OVERLOT GRADING, POND SR4 & UTILITY
 CONSTRUCTION DRAWINGS FOR
FALCON
MARKETPLACE
 FALCON, COLORADO

ISSUE	DATE
1ST SUBMITTAL	6-20-17
RESUBMITTAL	9-6-18

UTILITY CONSTRUCTION DOCUMENTS

FALCON MARKETPLACE

UTILITY
COVER SHEET

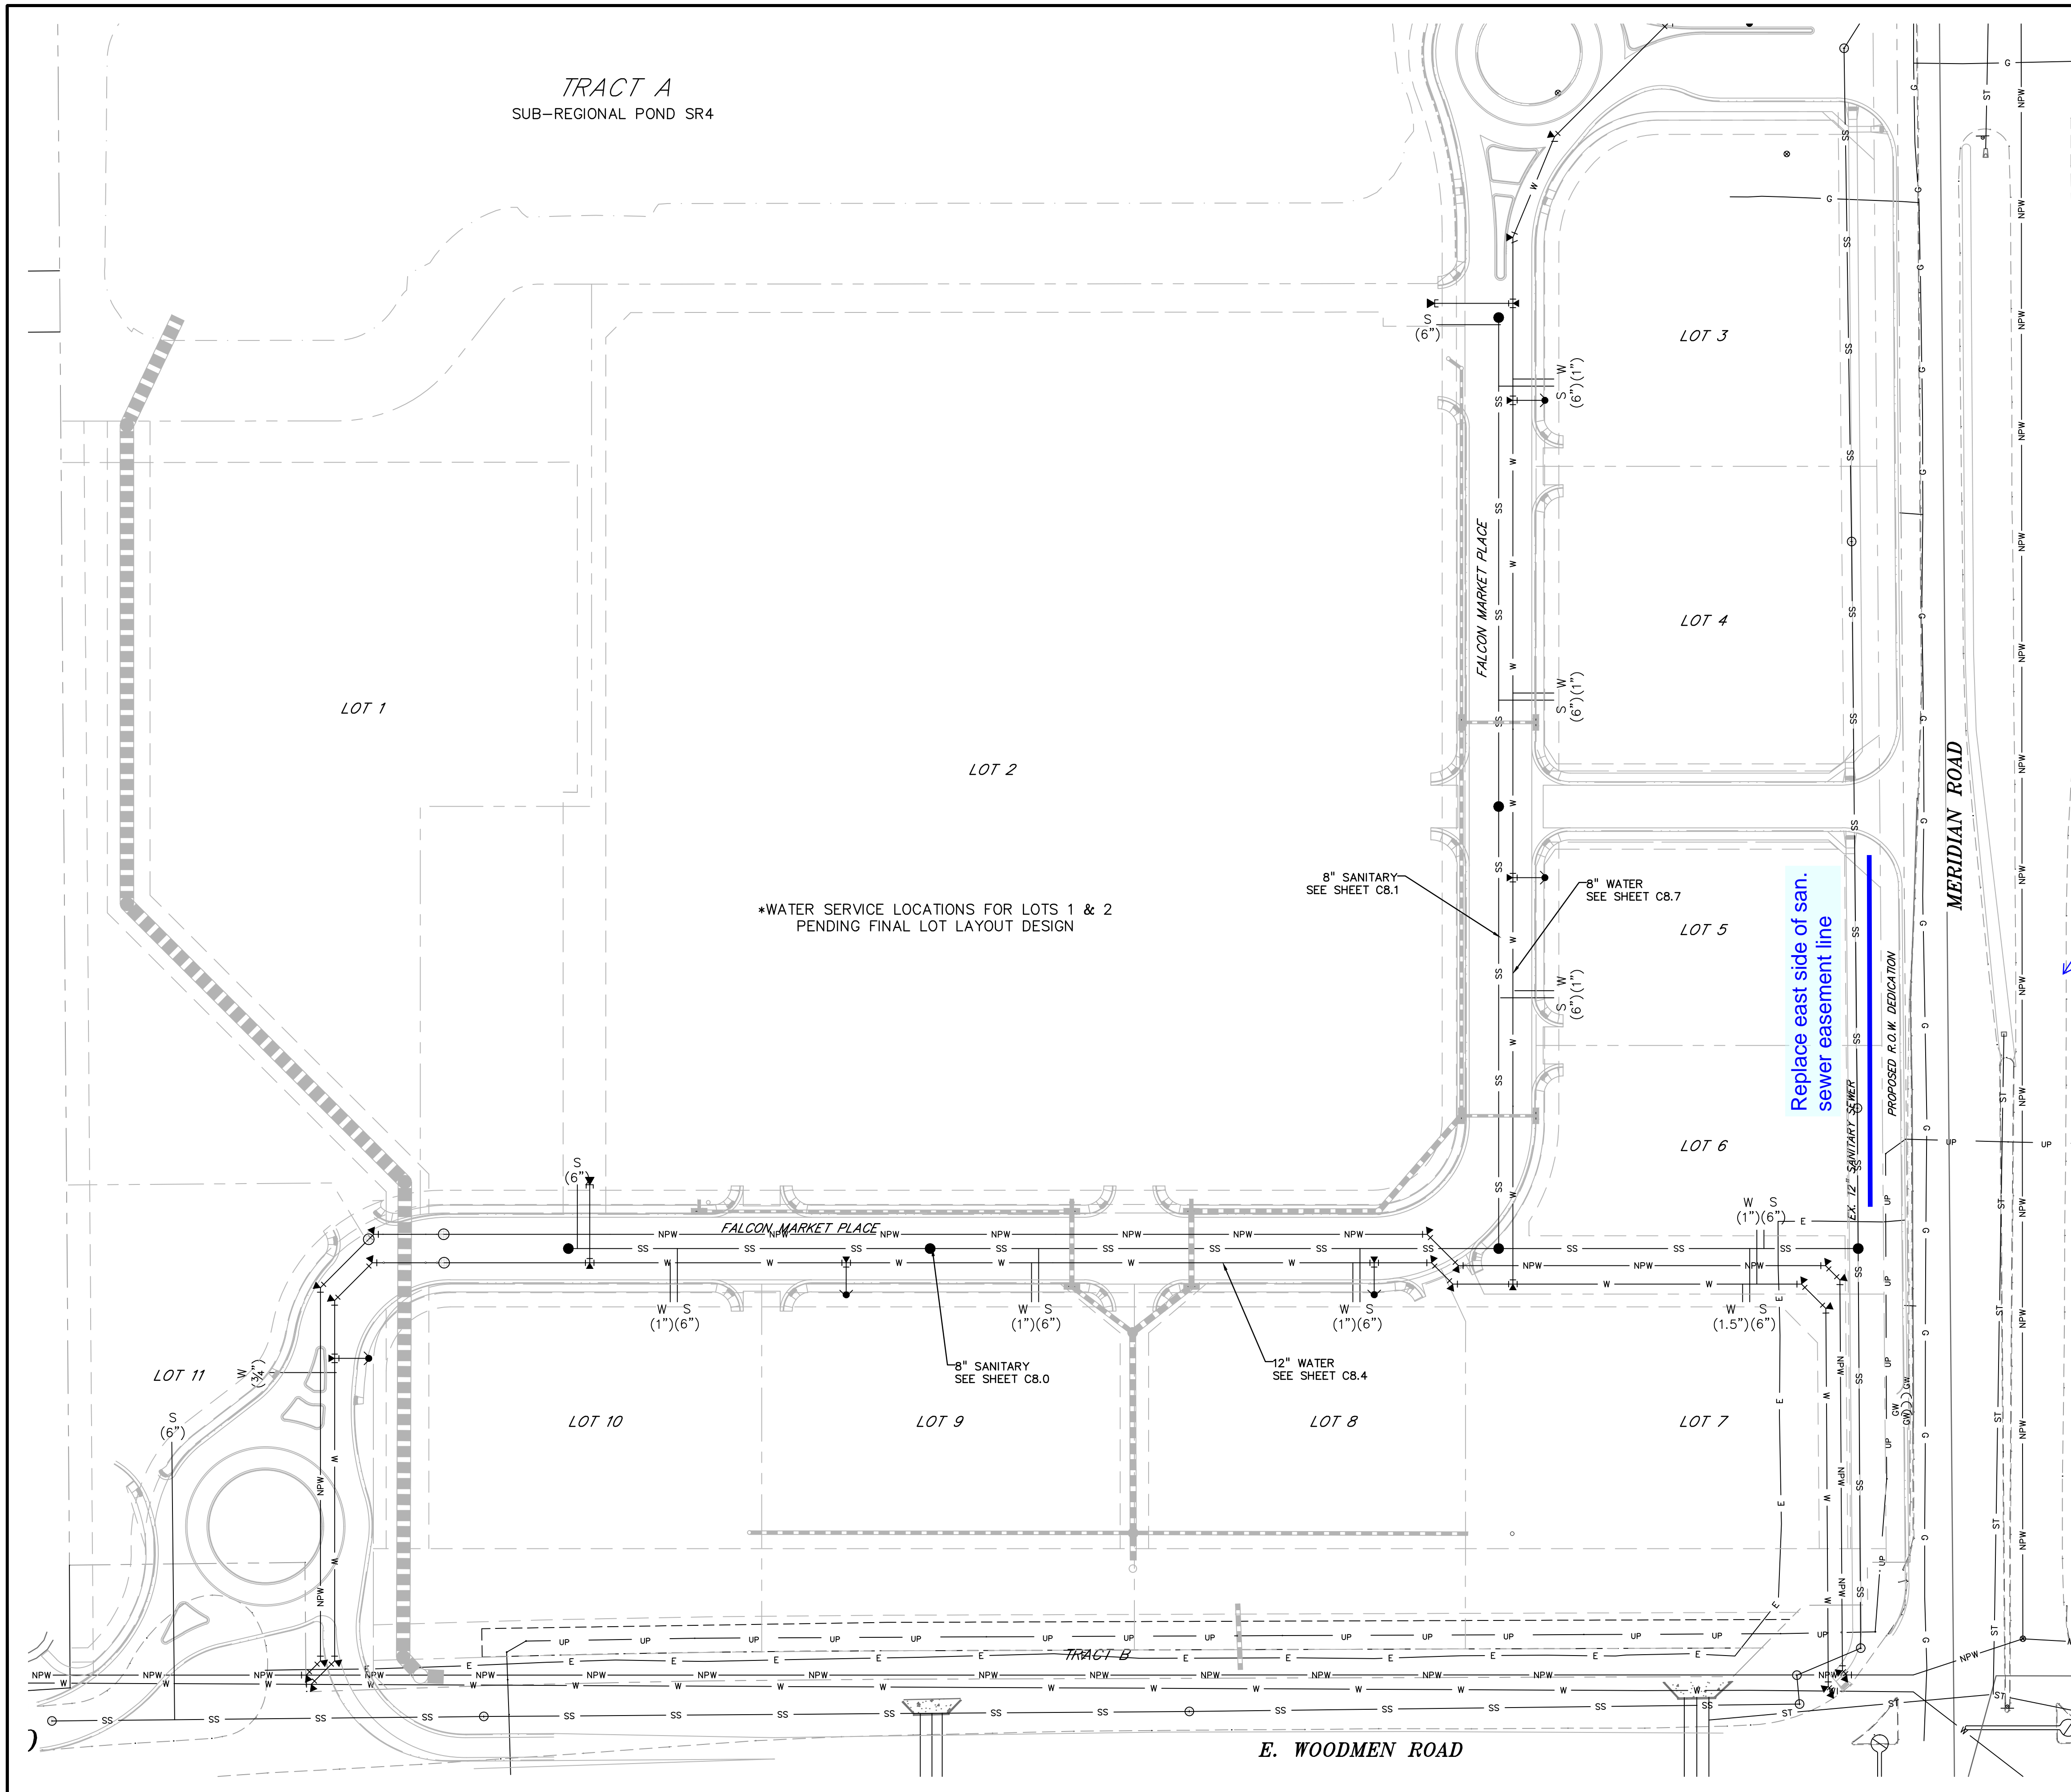
Provide completely signed version.
